Re: TMAC Responses to 2019 Nunavut Water Board Annual Report Comments

# HOPE BAY PROJECT

# Proponent's Response to Comments Received on the 2019 Nunavut Water Board Annual Report

**July 2020**

Figure 1. Runoff Monitoring Sites

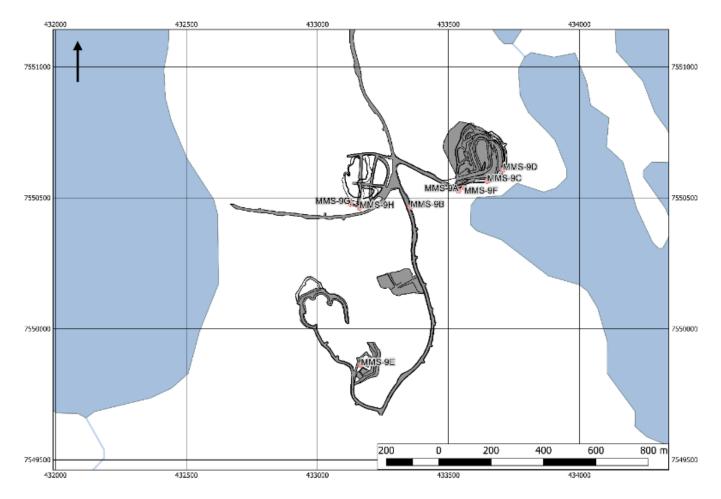
The location of runoff monitoring sites is not shown on a figure.

Please indicate the location of runoff sampling sites on a figure.

Runoff samplings sites are presented on Figure 1 below.

Figure 2. Patch Lake Sampling Locations

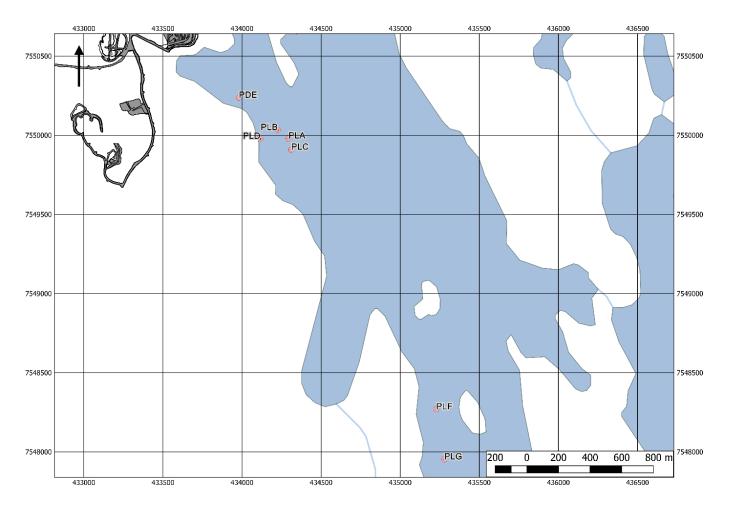
The location of monitoring sites for on-ice exploration drilling on Patch Lake, as well as onland exploration drilling are not shown on a figure.

Please indicate the location of on-ice and on-land drilling sites on a figure.

Patch Lake water sampling locations and on-land exploration drilling figures are provided below.

Figure 4: Comparison of Sulphate Concentrations and Loading Rates at Ephemeral Streams, Boston

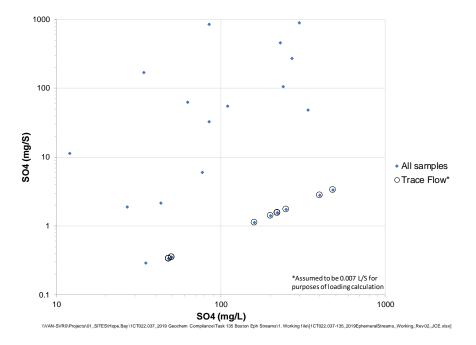
Can TMAC outline the stream sampling methodology and comment on the rationale for fewer flow measurements than samples collected as well as the potential uncertainty introduced with these disparities? Further to this request, can TMAC clarify the statement in Section 3.2 on loading rates and concentrations/trends observed in the sampled ephemeral streams in 2019?

Ephemeral stream flow rates are quantified using a bucket method whereby a stopwatch is used to determine the time for stream water to fill a container of a defined volume. The flow rate is determined multiple times and the average value accepted as the flow rate. A sample flow rate cannot be quantified when stream flow is too shallow to capture flow using the bucket method. In such a case, the flow rate is documented in qualitative terms, such as trickle or trace. Accordingly, there is flow data for all ephemeral samples collected and the "n/a" noted in Table 1 does not indicate the absence of flow or data, but that the flow rate was too low to quantify.

For the purposes of sulphate loading calculations, the flow rate for samples with qualitative flow rates was assumed to 0.007 L/s. A flow rate of 0.007 L/s was selected based on the minimum quantifiable flow rate of 0.008 L/S (measured at stream A2 in June 2019, Table 1) and assumes that the flow rate for streams with trace flow is less than samples that have flow that can be quantified. Figure 4 presents a comparison of observed sulphate concentrations and calculated loading rates for all ephemeral streams samples. Samples with assumed flow rates are denoted by circles in Figure 4. Figure 4 indicates that samples with flow rates too low to measure have lower loading rates, including the sample with maximum observed sulphate concentration (480 mg/L).
